MINUTES
BOARD OF BUILDING STANDARDS/
ARCHITECTURAL BOARD OF REVIEW/SIGN REVIEW
REVIEW MEETING
CITY OF LAKEWOOD
12650 DETROIT AVENUE
AUDITORIUM
FEBRUARY 12, 2026
5:30 P.M.
MEETING RECORDED
<https://www.lakewoodoh.gov/videos-2/>

SUMMARY APPROVED

Docket No. 01-10-26 (2035 Quail)

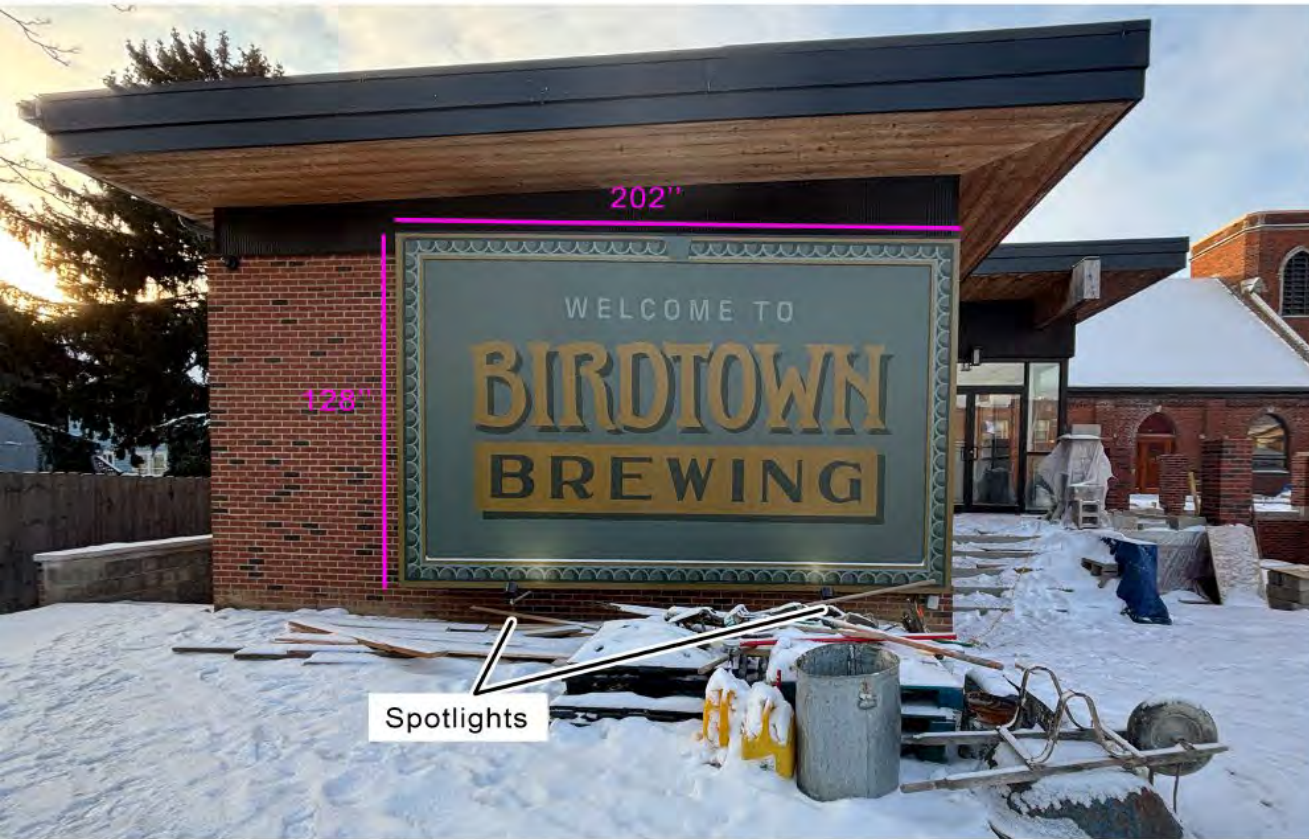
Kathy Clarke, Ace Lighting was present to discuss the updated plans. Discussion was made on the "B" sign on the white masonry.

- The "B" sign on the white masonry is not included.

Docket No. 09-77-25 (11730 Detroit)
The North Coast Apartments – New Development
Milan Milasinovic

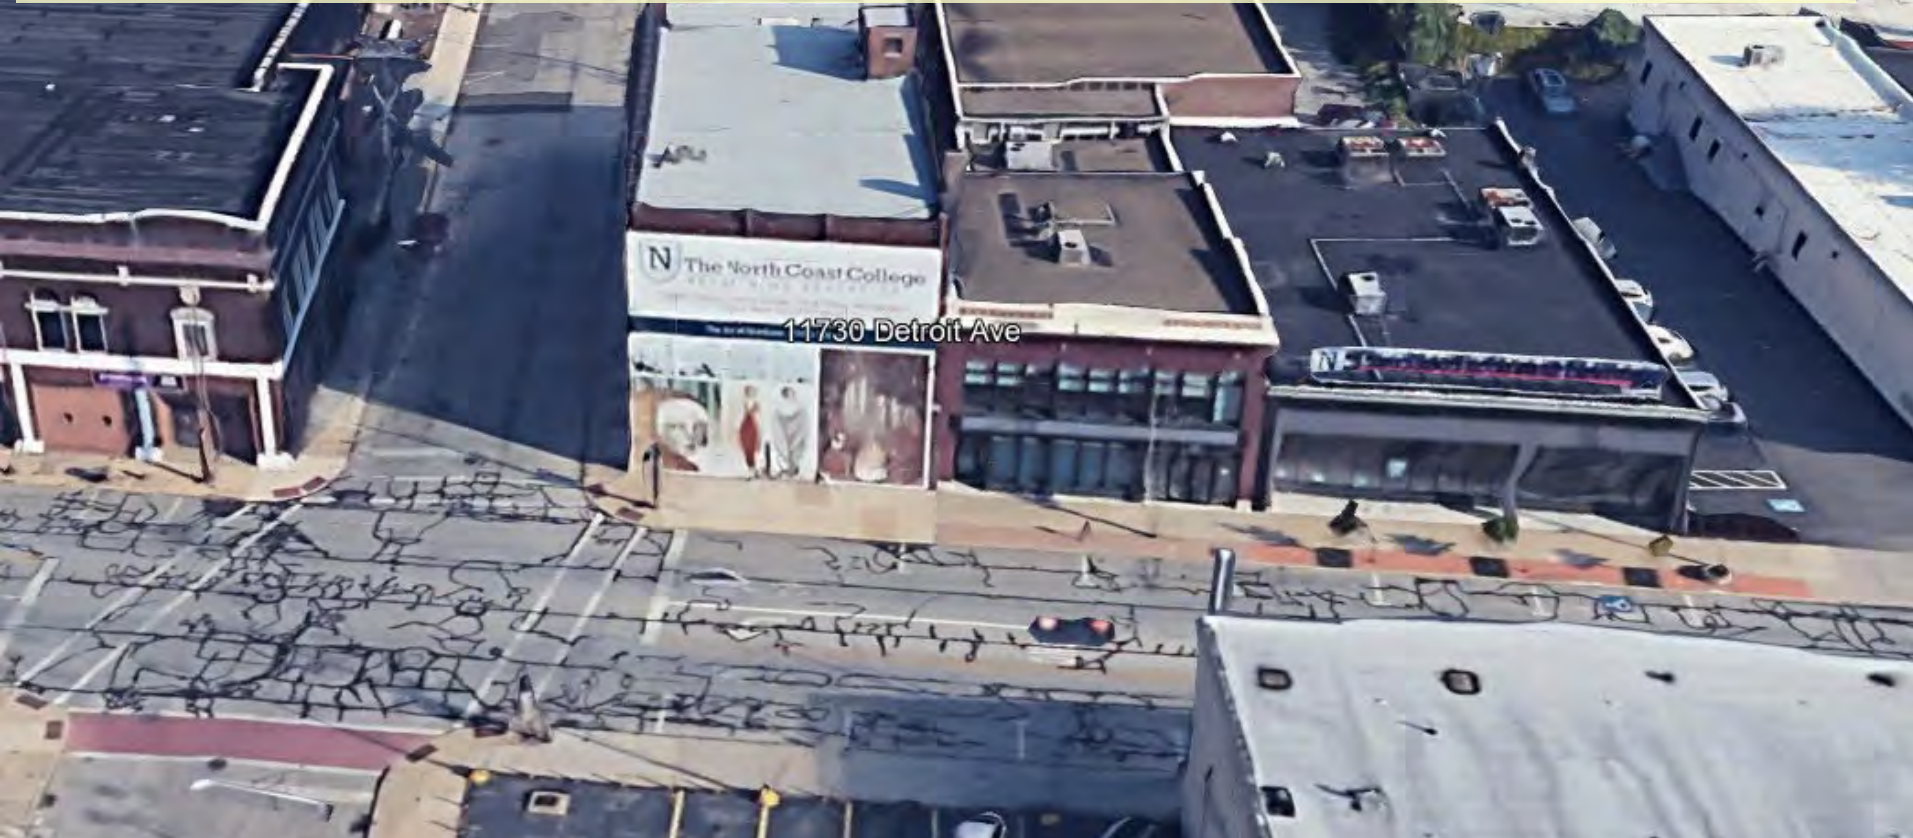
Eric Loomis, Loomis Companies and Frank Castrulari, FMC Architects, were both present to discuss their plans. They want to keep the classic look of the building. There will be 14 apartments and a retail café. Added balconies but would like to see them "squared off" instead of fluted as presented. They could be simpler, clean lines. Discussion on the metal siding and concerns that it will "oil can" so suggested to go with a heavier gauge metal to prevent that. Discussion on how to match the surrounding of the window so it is one continuous band and the how the windows will be trimmed since they are going into the brick. Restoration of the brick will be happening. Cut sheets for all exterior products are needed. More detail on the elevations is needed.

- ❑ Specific materials using, what is being replaced with what's remaining, color choices.
- ❑ Consider different material for balconies or paneling: they sort of contrast each other.
- ❑ Learn more about existing lentils and how they will be treated.
- ❑ 3D rendering please, especially from angle of street.

A motion was made by Ms. Plessner, Chair, seconded by Mr. Slaughterbeck to DEFER Docket No. 09-77-25. All the members voted yea; the motion passed.

FRONT ELEVATION
SCALE: 1/8" = 1'-0"

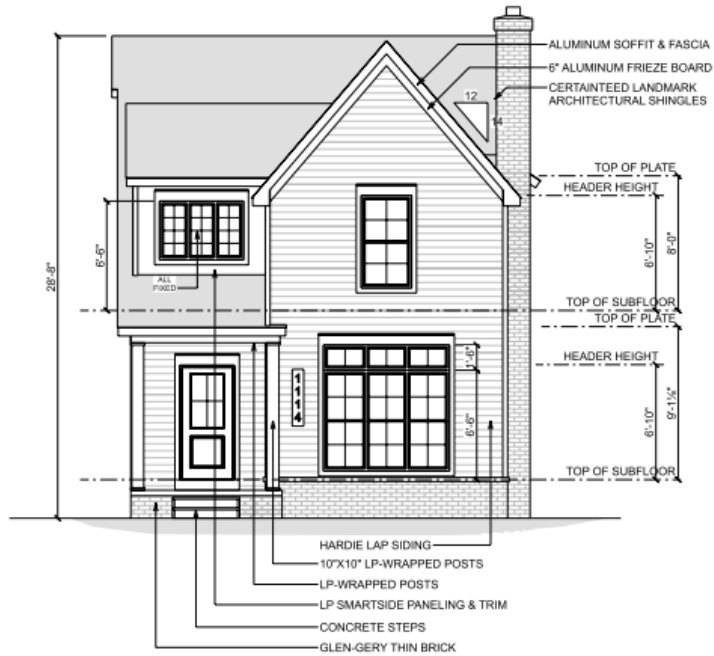
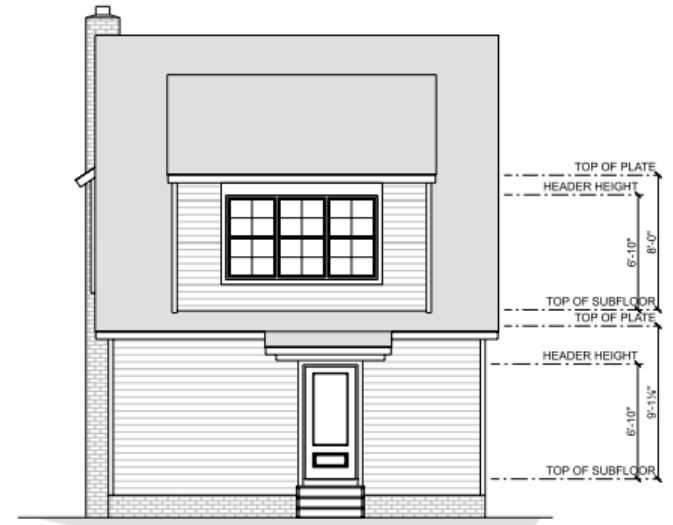
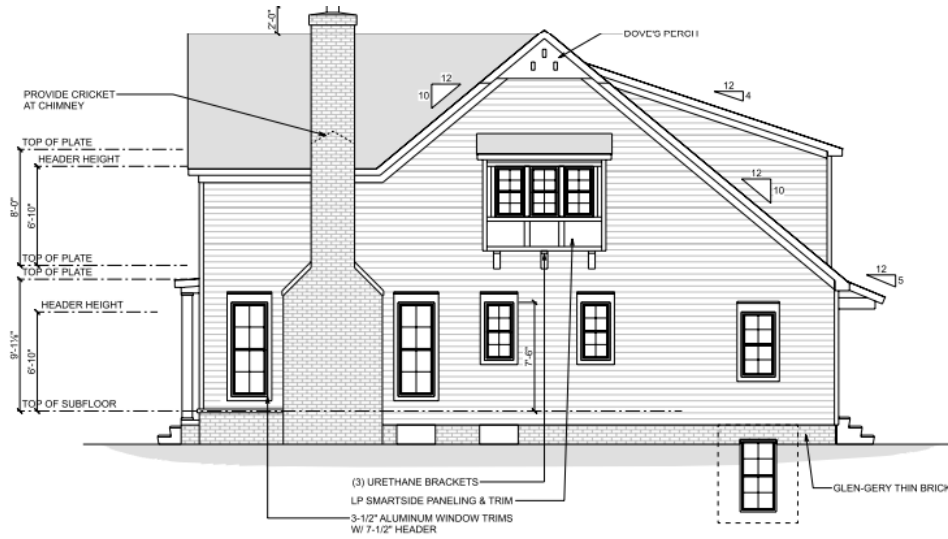
Jason Leon, property owner, Matt Bowen, Old World Classics, LLC were present to discuss. The board members commended Mr. Leon and Mr. Bowen on how they have modified things and done everything they were asked of them to get this approved. Glass was added to the front door, the chimney will be full brick and there is a new landscape plan. Mr. Leon is planning on keeping as many of the century old trees as possible.

- o Concern about removal of the century old trees, value of the homes and the surroundings of Clifton Park
- o Lack of respect for the historic district

While I am against the project generally, I am certainly against it as proposed. To the extent my suggestions are taken into consideration, I would at least recommend that the space over the garage be removed, which would bring the home more into the character of the neighborhood. I understand that would remove a bathroom and bedroom, but the home would then have 4 bedrooms and 3 bathrooms which is more in-line with the neighborhood that primarily consists of 3-4 bedroom homes with 1-2 bathrooms and would lessen the substantial side profile of the building significantly. Currently, as my home faces the side of the house, I think it would blot out the sun in the evening during winter months.

Another issue is the side porch, which looks like it was hastily added on to comply with the Board's requirements for corner lots. Taste is subjective, but I just think it looks odd and slapped on. My front porch faces that side of the house so I may be too nitpicky here, but even for something behind the 6-foot tall fence I think it is a strange design. I understand it is meant to match the front porch, but my same criticisms extend to that as well. It feels as though they were added simply because it is required.

3. I would also comment that the revised design minimally addresses some of the ARB's concerns from the prior meeting, but it continues to fail to address concerns the ARB had about scale and fit into the neighborhood, particularly on the west side of Forest Rd. I draw the ARB's attention to those same concerns in my comment of letter from the last meeting.

4. I highlight below my previous concerns that remain unaddressed with this revised design:
 - The proposed structure does not match prevailing scale in terms of footprint and fails to respect the width to height ratios in neighboring homes. This design is an outlier compared to every other home on the street. It intrudes as a vertical shard, conflicting with the aesthetic of the neighborhood. Its width to height ratio is less than 1.0; it is 0.79 (23' x 29'). Every other home on this side of the street has a width to height ratio greater than 1.0 (see table below using a 29' height standard).

A motion was made by Mr. Egervary, seconded by Mr. Stevenson to APPROVE Docket No. 12-114-25 as presented. All the members voted yea; the motion passed.

ARCHITECTURAL SITE PLAN

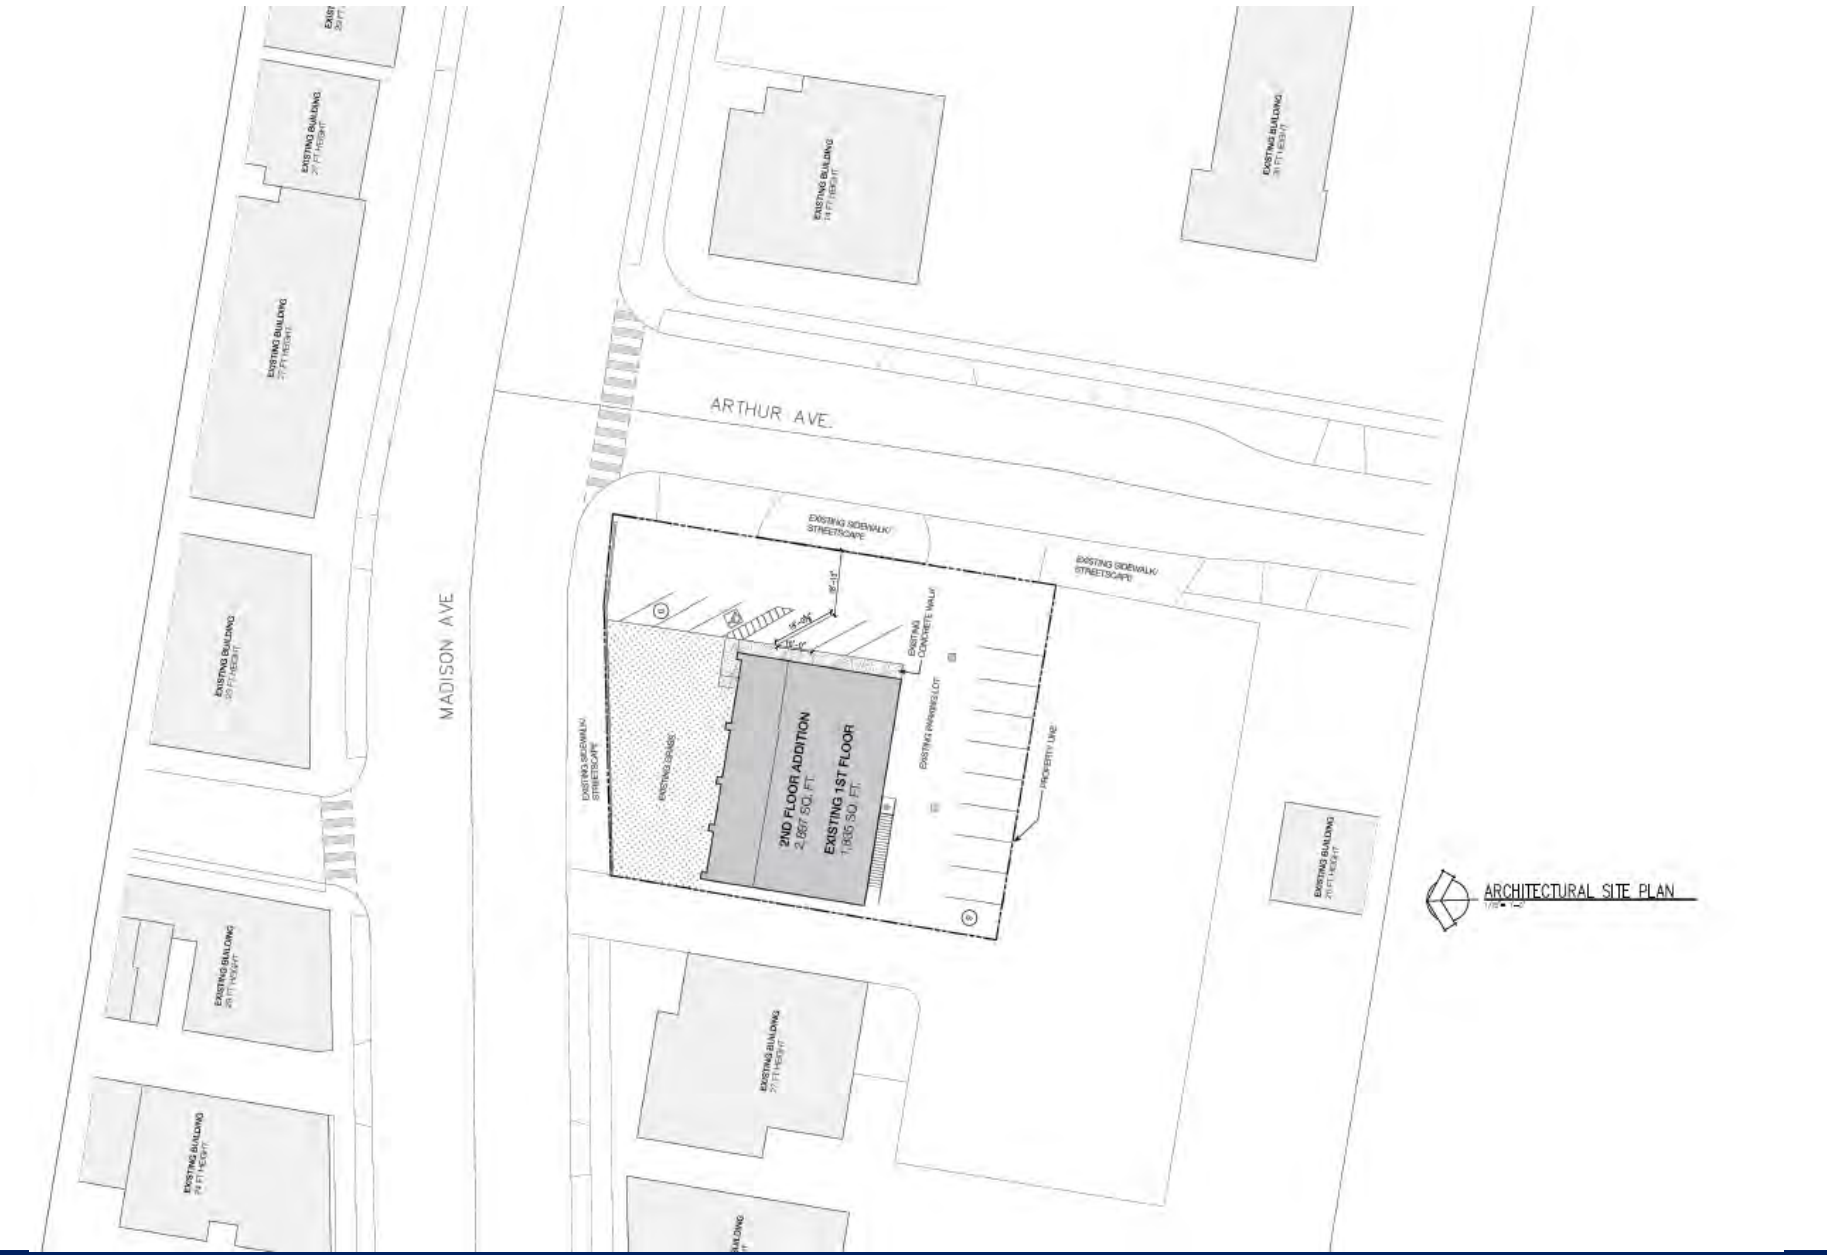
We are writing to share our feedback regarding the secondary notice for the proposed project at 15501 Madison Ave. Following the January 8th ABR meeting, we were glad to see the Board request a full site plan, as parking congestion and pedestrian safety remain top priorities for the neighborhood.

After reviewing the submitted plan, we believe there are some discrepancies between the drawings and the actual site conditions that may impact the Board's ability to assess safety. Specifically:

1. **Safety & Dimensions - East Lot:** The plan's measurements appear to overlap with the existing sidewalk and conflate what is actually *treelawn* as "existing sidewalk/streetscape." In reality, the parking area is tighter than depicted behind the angled spots, leading to frequent sidewalk obstruction. Because the current site plan lacks a clear delineation between the parking lot and the sidewalk, vehicles are frequently forced to use the pedestrian right-of-way to complete turns. This creates a persistent blind backing hazard, where drivers reversing from angled spots have zero visibility of approaching pedestrians—including children walking to nearby schools—until the vehicle has already entered the sidewalk path.

2. **Safety & Capacity - South Lot:** The plan depicts nine spots behind the building, whereas there are currently six painted spots behind the building and three more "unofficial" spots to the east of those six. These additional three spots impede the flow of traffic in and out of the southern most apron - again, causing congestion and ongoing blockage of the pedestrian sidewalk. In addition, we are concerned that adding the proposed exterior staircase will further tighten the aisle width, potentially falling short of code requirements and increasing sidewalk blockage.

- **Professional Survey:** We request that the applicant provide a stamped, scaled survey from a licensed surveyor. This should clearly delineate the private property line versus the public right-of-way (including the Arthur Avenue sidewalk AND treelawn separately).
- **Existing vs. Proposed Comparison:** We request a plan that accurately reflects the *current* number of painted spots versus the *proposed* number, ensuring all proposed spots meet Lakewood's minimum aisle width and stall dimension requirements.

- **Egress Impact:** We request a formal review of the South parking lot aisle width, specifically calculating how the new exterior staircase will impact the maneuverability of vehicles.
- **Pedestrian Traffic Study:** Given the proximity to schools and local dining, we suggest the City verify that the proposed density of parking does not create a "blind backing" hazard onto the Arthur sidewalk.

SOUTH ELEVATION

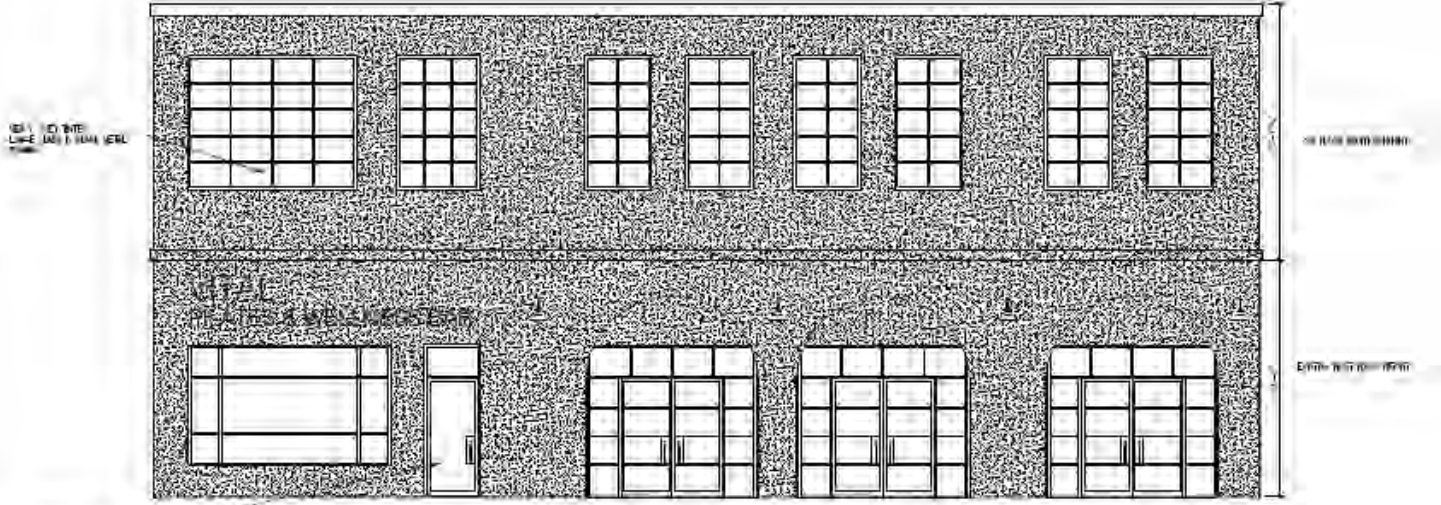
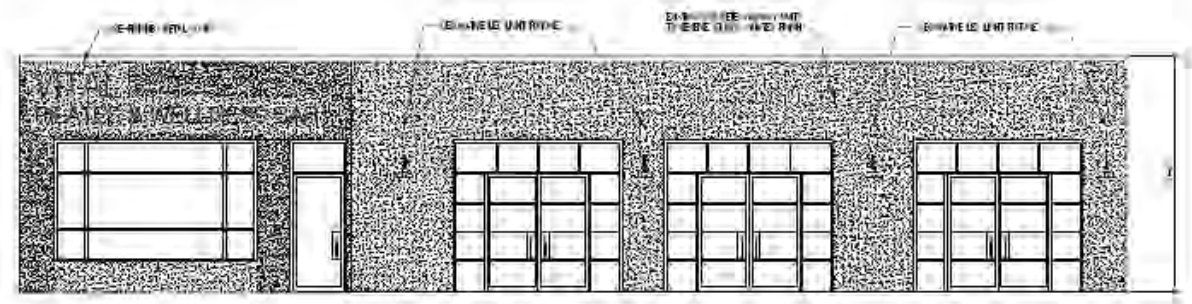
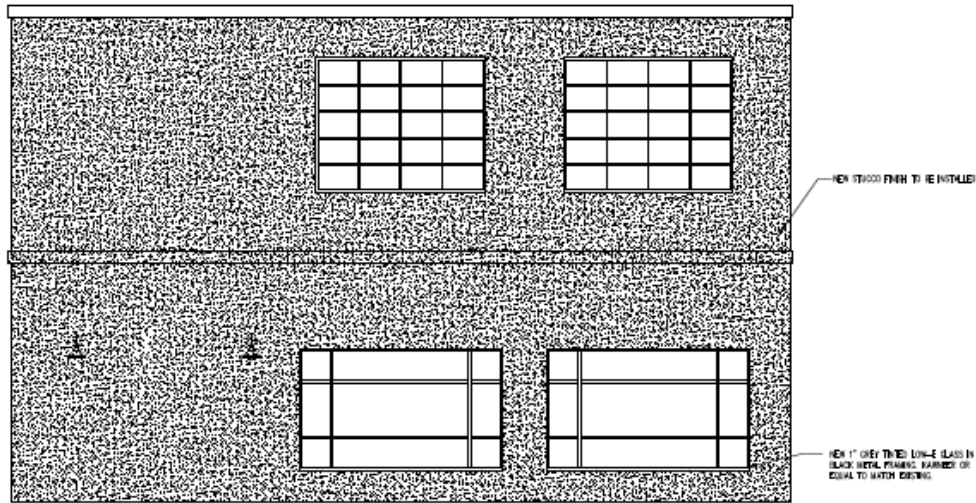
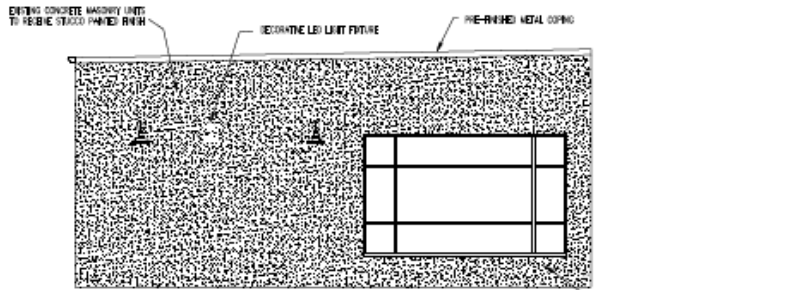
Jake Szaraz and Liz Gonzalez, MJM Building Standards were present to discuss the plans. Discussion was made on how the building is aligned with other businesses on Madison. They are trying to create a pedestrian friendly façade with a covered patio in front. An 8 foot parapet was added to the front of the building and the windows were shrunk to be more in scale with the first floor. Mr. Szaraz feels the left arches break up the façade. There was also discussion on the air conditioning unit on the side and Mr.

Szaraz stated that it will be moved as there will be roof top units added. The board members discussed the following items:

- Make the 3 square window match the rest
- Clean up the details so the width of the windows matches those below it
- Consider matching the first floor window on the left side of south elevation for the second floor in the same spot
- What is the material used for the horizontal band? Stucco
- Center the light fixtures on column or center of space on rear elevation
- Cut sheets needed with the final colors, window type, stucco type, exterior lights and trim details
- Add more landscaping up front to enhance and extend walk to Madison to make more welcoming

A motion was made by Ms. Plessner, Chair, seconded by Mr. Slaughterbeck to DEFER Docket No. 01-07-26. All the members voted yea; the motion passed.
